## LATITUDE MOTOR WIRING

**Service**

Carefree has determined a potential problem may exist with the wiring on the Latitude Awning. This can cause the Direct Response system to work incorrectly where the awning could automatically extend when the power switch is left in the ON position.

FL031

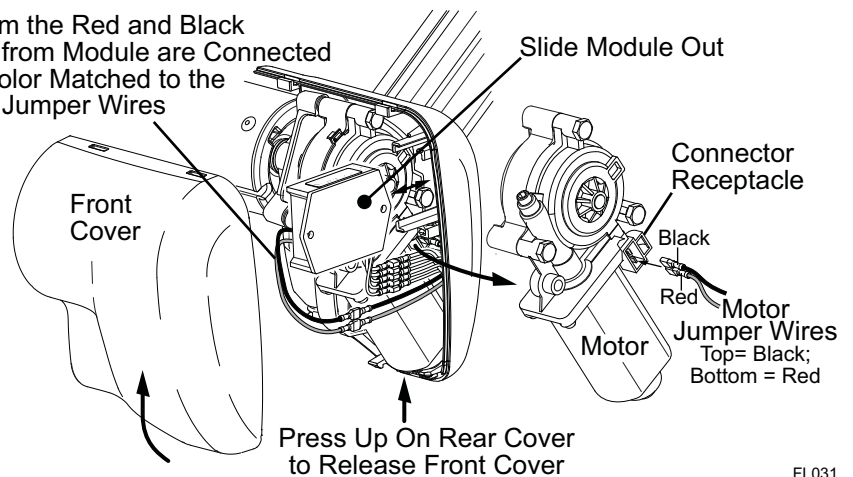
Confirm the Red and Black Wires from Module are Connected and Color Matched to the Motor Jumper Wires

1. Remove the front cover. The cover snaps onto the rear cover. To remove, press the bottom of the rear cover until the front cover releases then lift the front cover off.
2. Slide the sensor module out and allow it to hang down out of the way.
3. At the motor receptacle remove the two wires and reconnect with the BLACK wire to the top terminal and the RED wire to the bottom terminal.
4. Slide the module into the mounting fingers of the rear cover. Ensure that all wires are firmly connected.

FL032

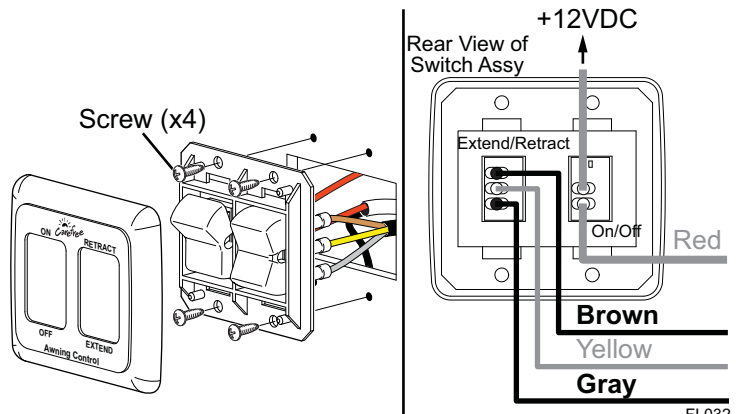
The installer may have reversed the switch wires so that operation matched the switch labels if the motor wires were reversed.

1. Snap the switch bezel off the switch frame.
2. Remove the 4 screws holding the switch frame and carefully pull the switches and wires out from the mounting surface.
3. Confirm that the BROWN and GRAY wires are connected as shown. Reverse if necessary.
4. Remount the switches and the switch bezel.
5. Repeat the operational test above.
